Design Review Board

August 8, 2018 5:30-7:00 PM City Council Briefing Center

- 7) Recommendation Meeting for Wonder Parking Garage
- Dean Gunderson

8) Recommendation Meeting for Father Bach Haven V

EXTERIOR ELEVATIONS - EAST

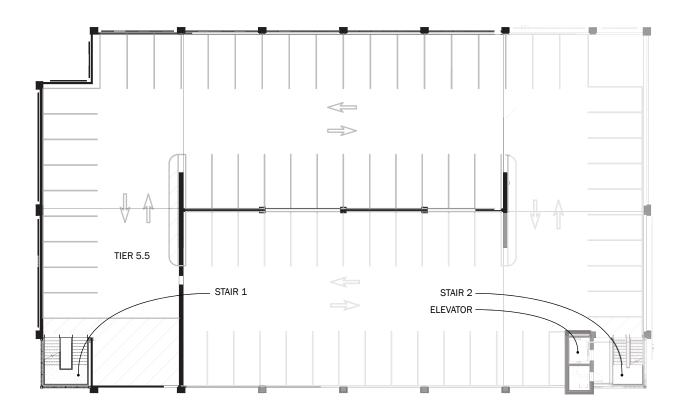
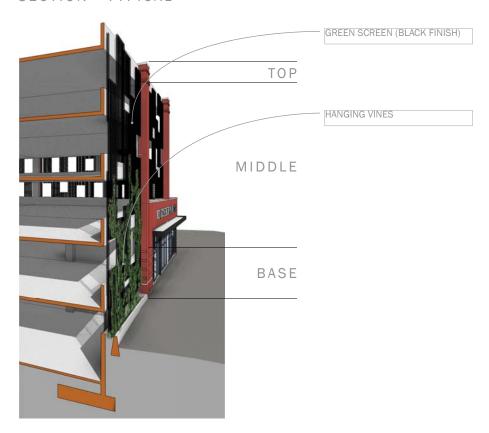
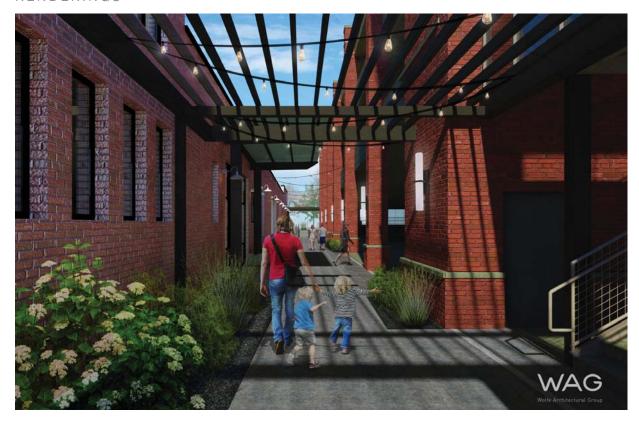
4. Base, Middle, Top: The proposed structure has no discernable base or top elements, with the exception of the stairway structure, and planters located where the façade-mounted trellis structures meet the ground plane. What opportunities exist to bring the façade design into compliance with the base/middle/top requirements in Section 17C.124.520?

5. Façade Design: The street-facing facades of parking levels within a building shall be treated in such a way as to seem more like a typical floor, rather than open slabs with visible cars and ceiling lights. Currently, the design only incorporates one (Planting designed to grow on the façade) of the two required elements in code Section 17C.230.310 Exterior Design of Parking Structures to mitigate the appearance of the integrated ramps. What other opportunities are there to lessen the prominence of the sloped parking decks?

Site Plan/Floor Plan Figure 1

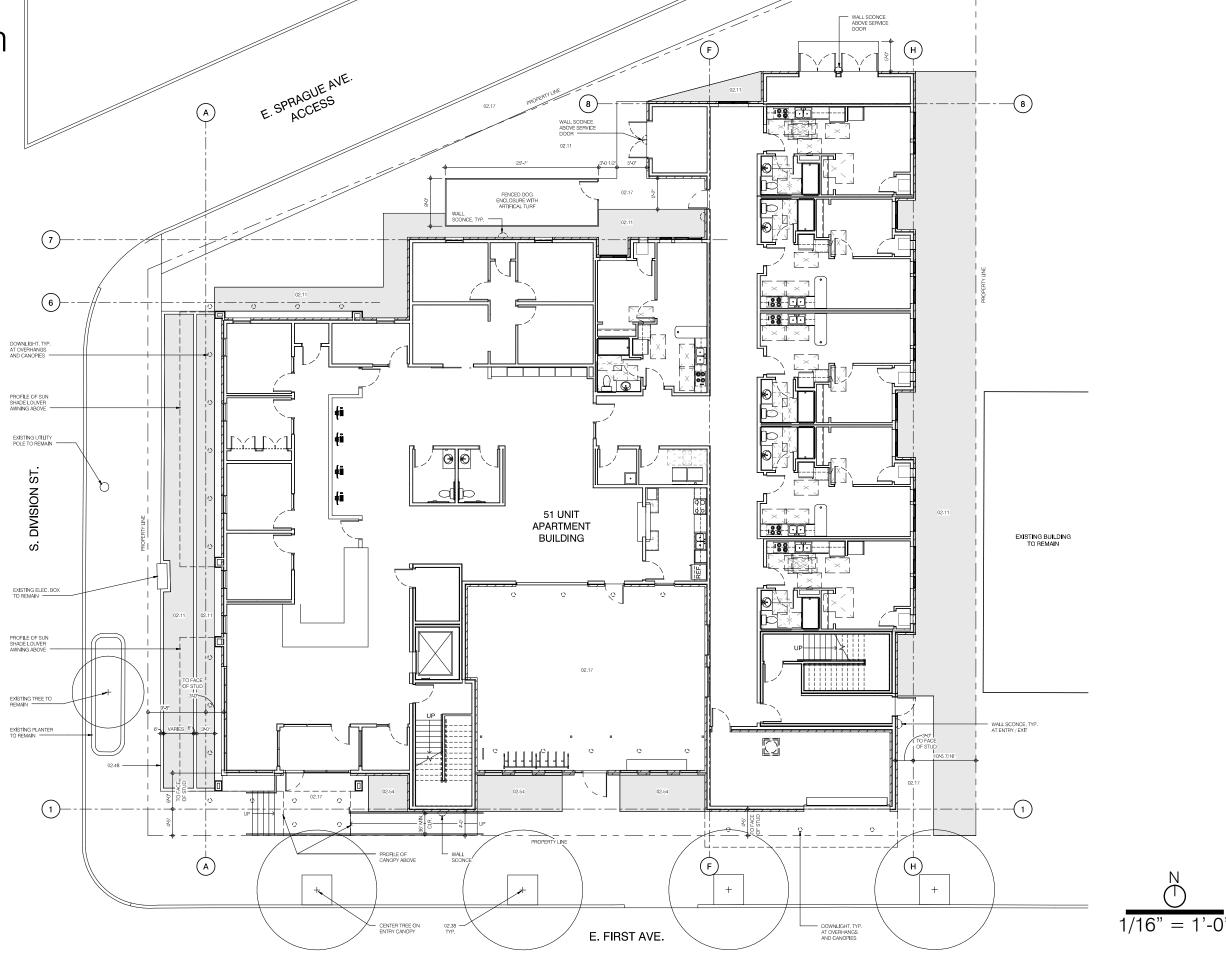
6. The applicant shall explore opportunities to create a more pedestrian friendly environment along E. 1st Avenue, to include (but not limited to): overhead weather protection, façade articulation/fenestration, material change, art work, etc.

The building design has been modified to create a more pedestrian friendly environment along E. 1st Avenue where feasible. Since the Design Review Workshop, the building has been modified based on programmatic needs at the southeast corner of the building. These programmatic needs include a trash room with roll-up door, a trash chute, and relocation of the stair tower. Windows have been added to the south building elevation at floors 2 - 4 above the ground floor trash room to provide additional fenestration. Because the stair towers must maintain two hour fire resistance rating, windows are not provided at these walls. Modifications of these facades have included façade articulations and material changes to help break down the scale of some of these walls. The building's brick base is maintained to help create a pedestrian scale along these walls.

The entry canopy has been extended to be 7'-6" in depth beyond the upper floor cantilever. This provides weather protection for residents, staff, and visitors. The building is stepped back at this location to provide a ramp and stair up to the finish floor level of the building from the adjacent sidewalk grade. As indicated in the Collaborative Workshop, the Owner in conjunction with Spokane Police (CPTED), are very sensitive to past and on-going instances at other low-income /

As a compromise, overhead weather protection has been offered along the trash room with a metal canopy that is 6' in depth from the building façade over the sidewalk. This element will also help provide human scale along the south building elevation at this portion of the building.

Please refer to Figures 1, 8, 9

Planting Plan Figure 5

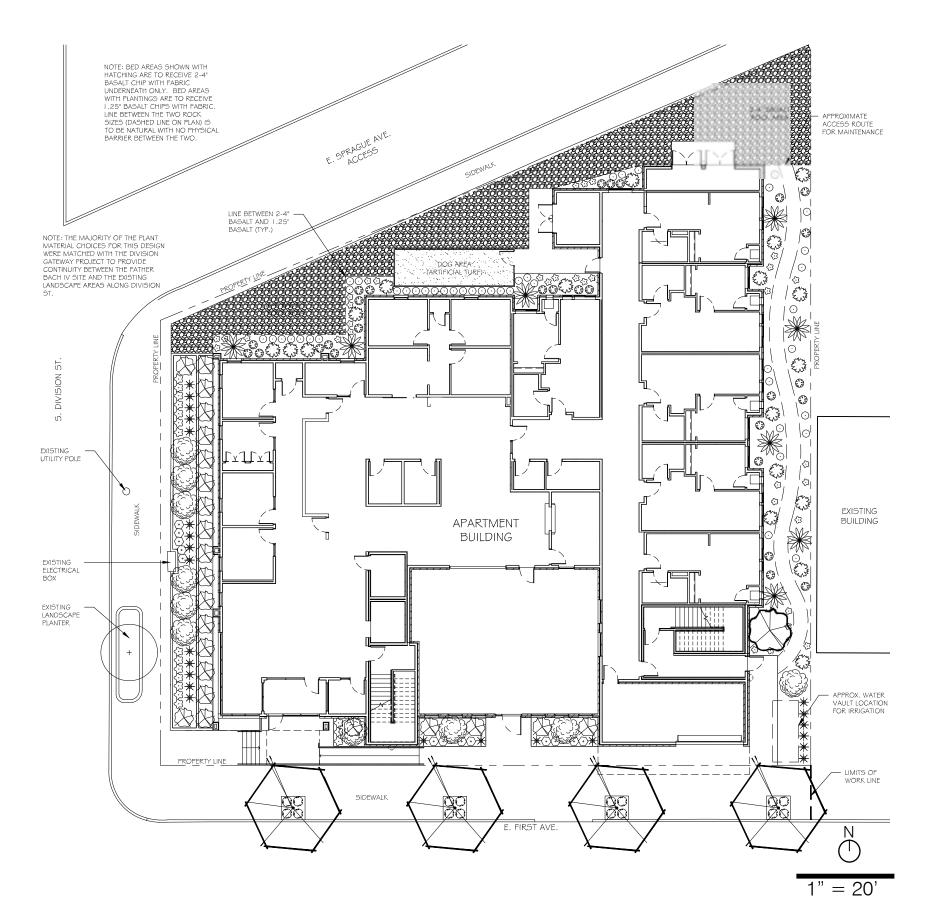
1. The applicant shall provide a more well-refined landscaping concept, addressing both the frontages and side/rear yard areas.

Plantings and crushed rock mulch will be provided on all sides of the building. New street trees will be added along E. 1st Ave. The existing street tree and plantings in the sidewalk planter on S. Division will remain. New plantings along S. Division Street will be consistent with that along the rest of S. Division Street. These Plantings will be located in a tiered planter.

Please refer to Figure 5 - Landscaping for detailed information.
